Re: TMAC Responses to 2019 Nunavut Water Board Annual Report Comments

HOPE BAY PROJECT

Proponent's Response to Comments Received on the 2019 Nunavut Water Board Annual Report

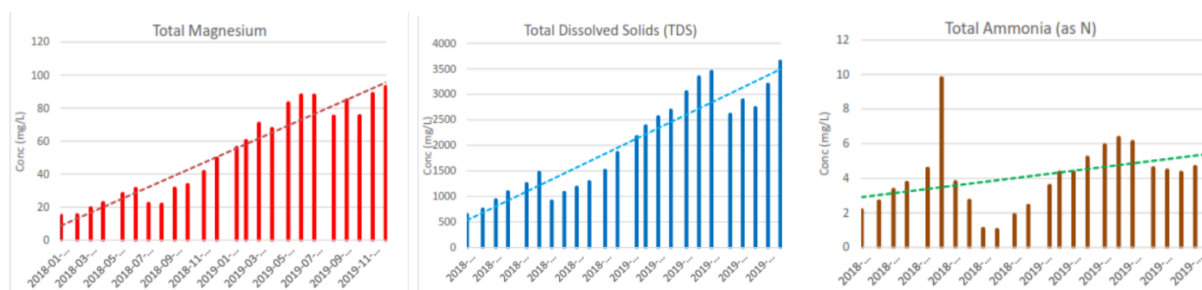
Some parameters seem to present upward trends in the concentration at the tailing impoundment area (water quality station TL-1). Three Histograms were prepared for some PCOCs; the upward trend is clear for the parameters Total Magnesium and Total Dissolved Solids. The parameter Total Ammonia, as well, indicates a slightly upward trend.

All modelling work to date (SRK 2017a, 2018, 2019, 2020) includes a general trend of increasing concentration for most parameters as contact water sources generally contain higher concentrations compared to natural runoff flowing to the Doris TIA. The Doris TIA was a natural lake (Tail Lake) before the construction of the North Dam. Since then, contact water collected around the Doris Mine Site, Doris mine water and the tailings from the process plant have been deposited in the Doris TIA. These contact water sources all have elevated concentrations for some parameters compared to the baseline concentrations observed in Tail Lake. It is an expectation, that the concentration trend observed for these parameters would be increasing over time. The focus of the 2019 W&LBA was to assess the fit and accuracy of the model predictions when compared to measured values, as required under Schedule B Item 4.

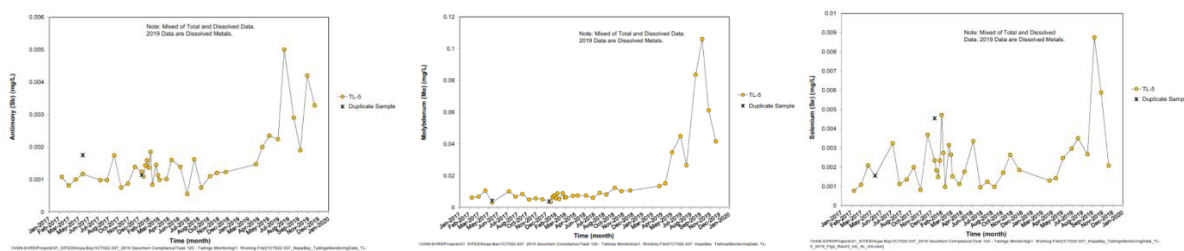
Several parameters showed increasing trends in the process plant tailings water discharge to the TIA in 2019, including spikes in concentrations in August or October.

Please explain why concentrations of magnesium, molybdenum, antimony and selenium increased in the process plant tailings in 2019.

Please explain why many parameters exhibited a spike in concentration in August or October in the process plant tailings. We acknowledge that although the TIA did not discharge to the environment in 2019. However, ongoing increases in tailings process water concentrations may affect the ability to meet TIA discharge limits in future.

Figure 1. Runoff Monitoring Sites

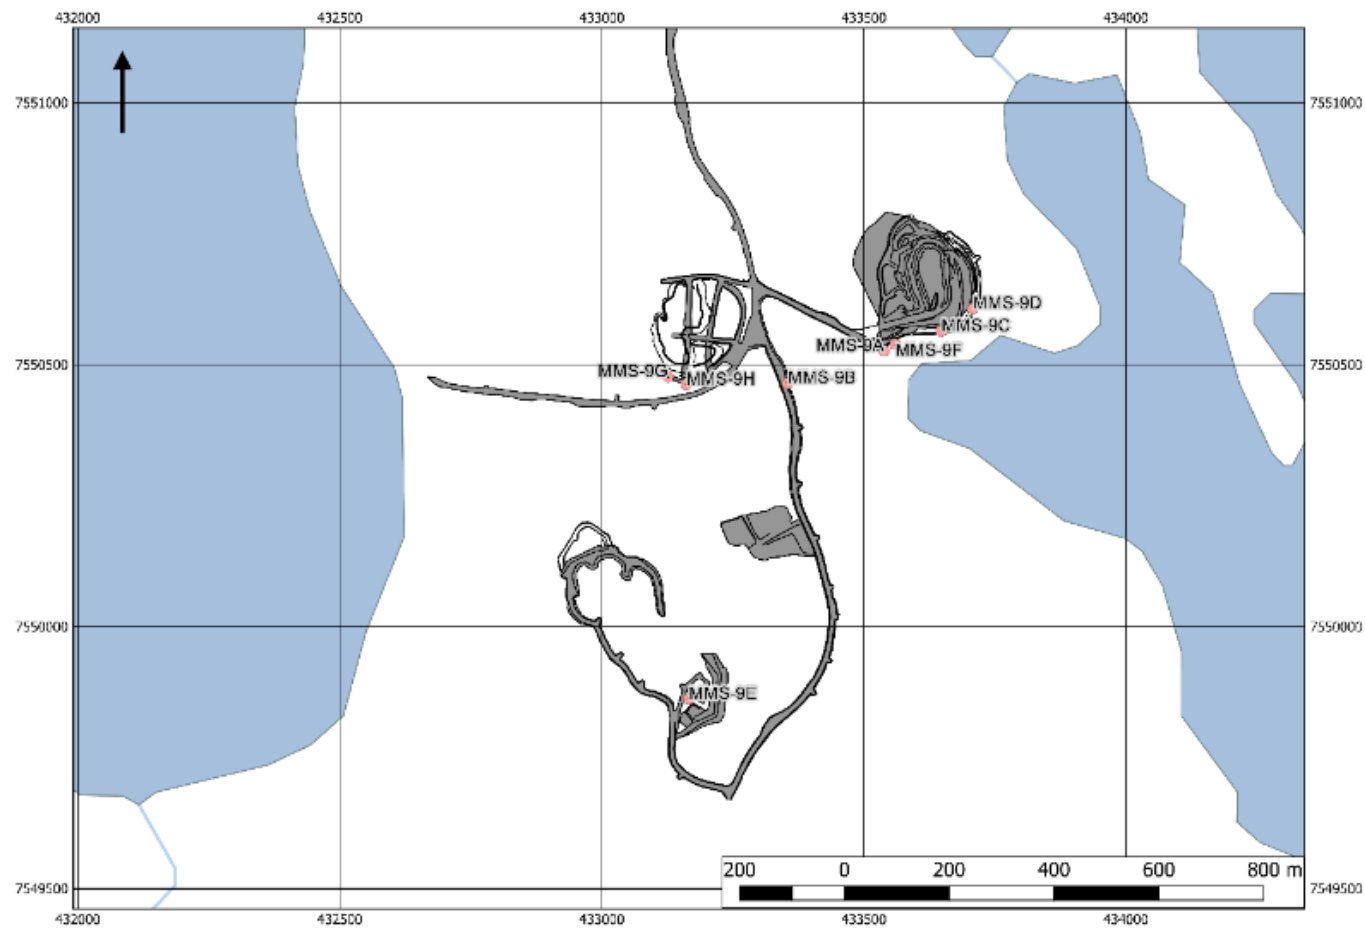
The location of runoff monitoring sites is not shown on a figure.

Please indicate the location of runoff sampling sites on a figure.

Runoff samplings sites are presented on Figure 1 below.

Figure 2. Patch Lake Sampling Locations

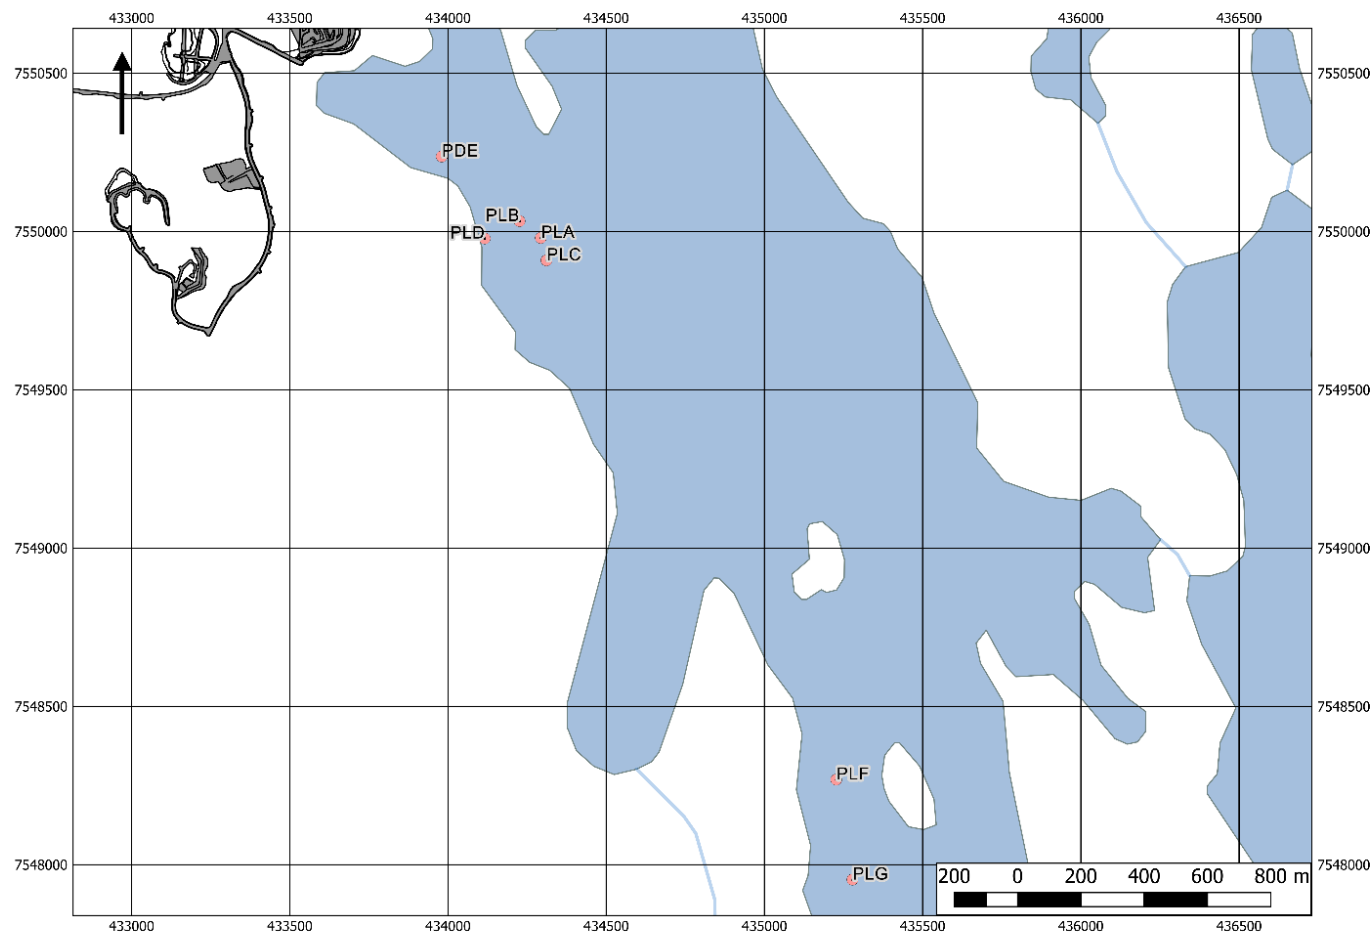
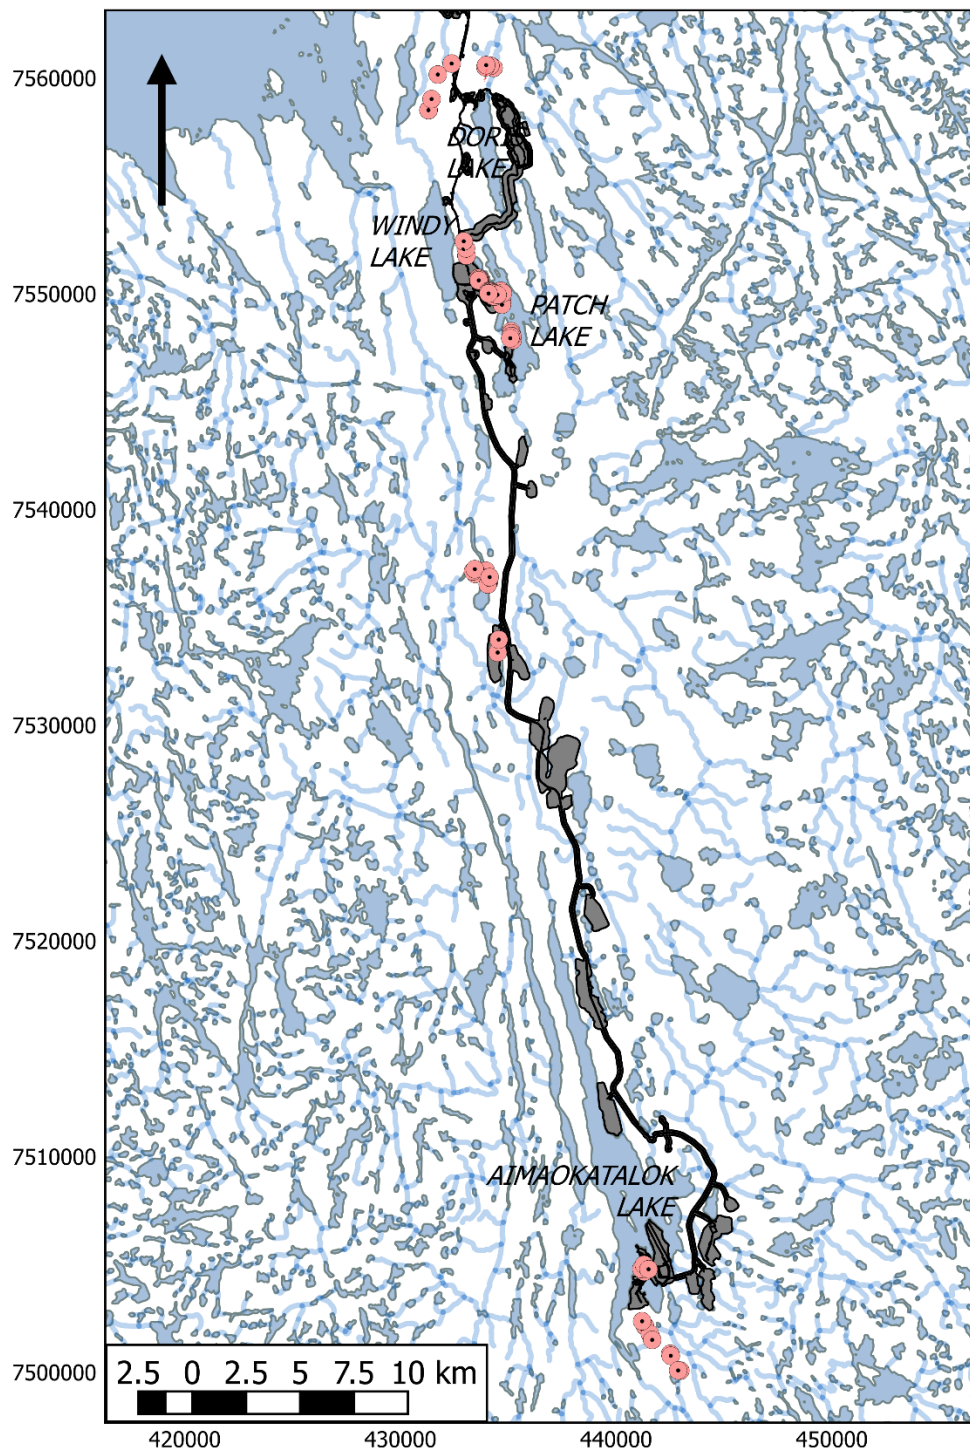
The location of monitoring sites for on-ice exploration drilling on Patch Lake, as well as on-land exploration drilling are not shown on a figure.

Please indicate the location of on-ice and on-land drilling sites on a figure.

Patch Lake water sampling locations and on-land exploration drilling figures are provided below.

Figure 4: Comparison of Sulphate Concentrations and Loading Rates at Ephemeral Streams, Boston

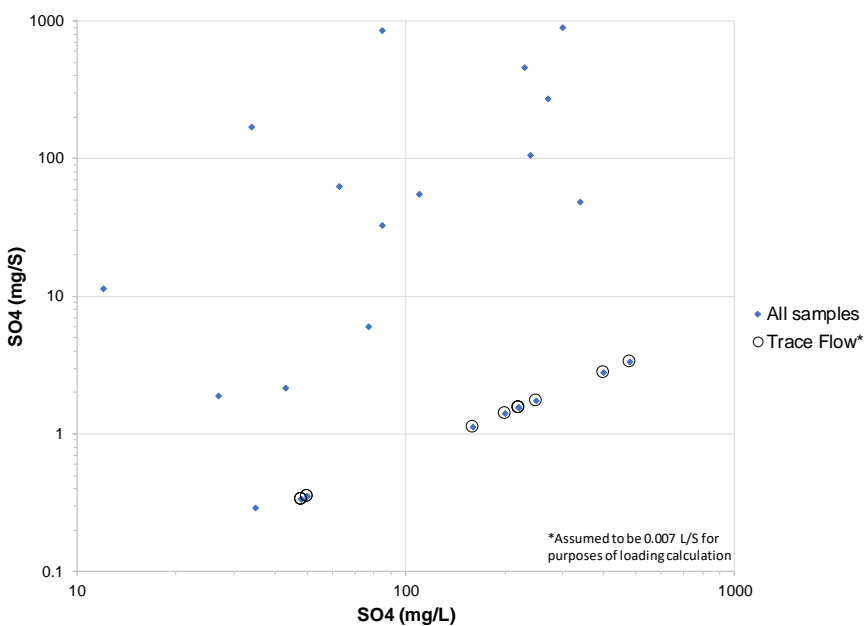
Can TMAC outline the stream sampling methodology and comment on the rationale for fewer flow measurements than samples collected as well as the potential uncertainty introduced with these disparities? Further to this request, can TMAC clarify the statement in Section 3.2 on loading rates and concentrations/trends observed in the sampled ephemeral streams in 2019?

Ephemeral stream flow rates are quantified using a bucket method whereby a stopwatch is used to determine the time for stream water to fill a container of a defined volume. The flow rate is determined multiple times and the average value accepted as the flow rate. A sample flow rate cannot be quantified when stream flow is too shallow to capture flow using the bucket method. In such a case, the flow rate is documented in qualitative terms, such as trickle or trace. Accordingly, there is flow data for all ephemeral samples collected and the “n/a” noted in Table 1 does not indicate the absence of flow or data, but that the flow rate was too low to quantify.

For the purposes of sulphate loading calculations, the flow rate for samples with qualitative flow rates was assumed to 0.007 L/s. A flow rate of 0.007 L/s was selected based on the minimum quantifiable flow rate of 0.008 L/S (measured at stream A2 in June 2019, Table 1) and assumes that the flow rate for streams with trace flow is less than samples that have flow that can be quantified. Figure 4 presents a comparison of observed sulphate concentrations and calculated loading rates for all ephemeral streams samples. Samples with assumed flow rates are denoted by circles in Figure 4. Figure 4 indicates that samples with flow rates too low to measure have lower loading rates, including the sample with maximum observed sulphate concentration (480 mg/L).
